CITY OF CAMBRIDGE
BUILDING DIVISION

THESE PLANS have been examined for compliance
with the Ontario Building Code Requirements. A
Building Permit is in Order to issue subject to any
changes noted under the condition that the building will
be constructed in accordance with the code

BASEMENT PLAN EL-1
BARLASSINA CONSTRUCTION
CITY OF CAMBRIDGE

MODEL:
GARDEN 2
SCALE:
3/16"=1'-0"
PROJ. No.
21-35
DWG. No.
1

REAR ELEVATION 1

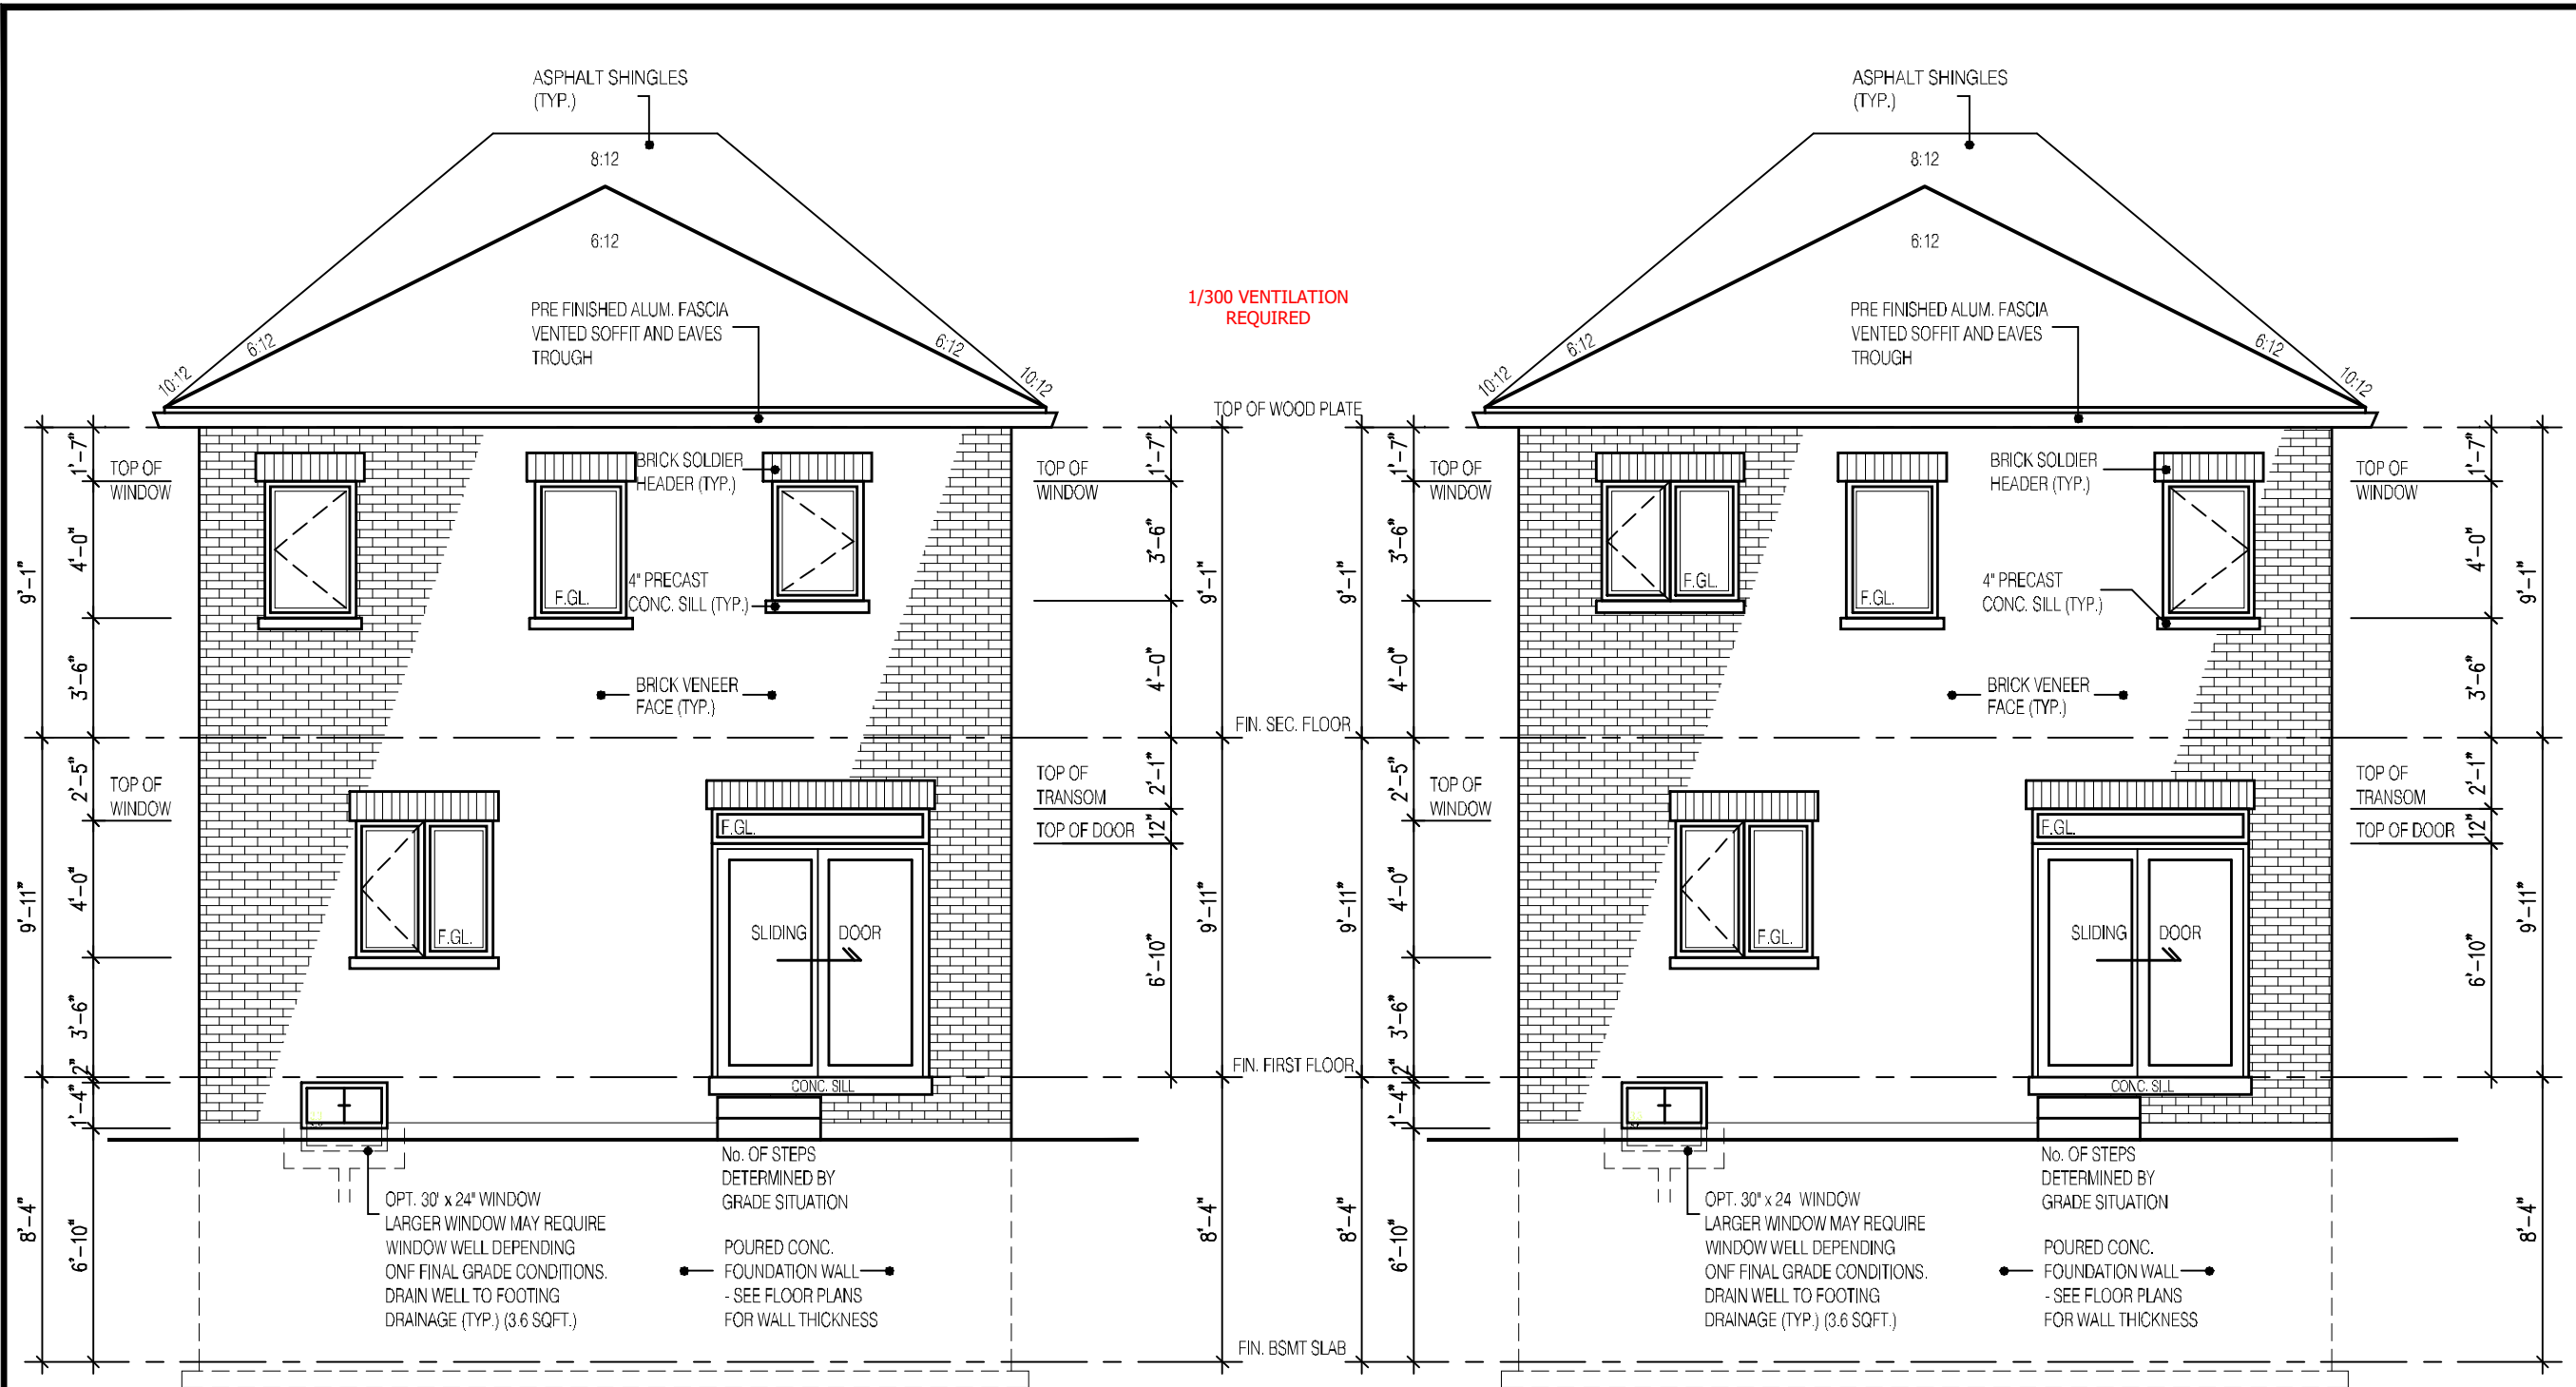
POURED CONC. FOUNDATION WALL -SEE FLOOR PLANS FOR WALL THICKNESS

MAX 5" DIA OPENING PERMITTED IN THIS WALL

PROVIDE STAIR, GUARD AND LANDING OR
INSTALL PERMANENT BLOCKING TO
RESTRICT DOOR OPENING TO MAX. 4".
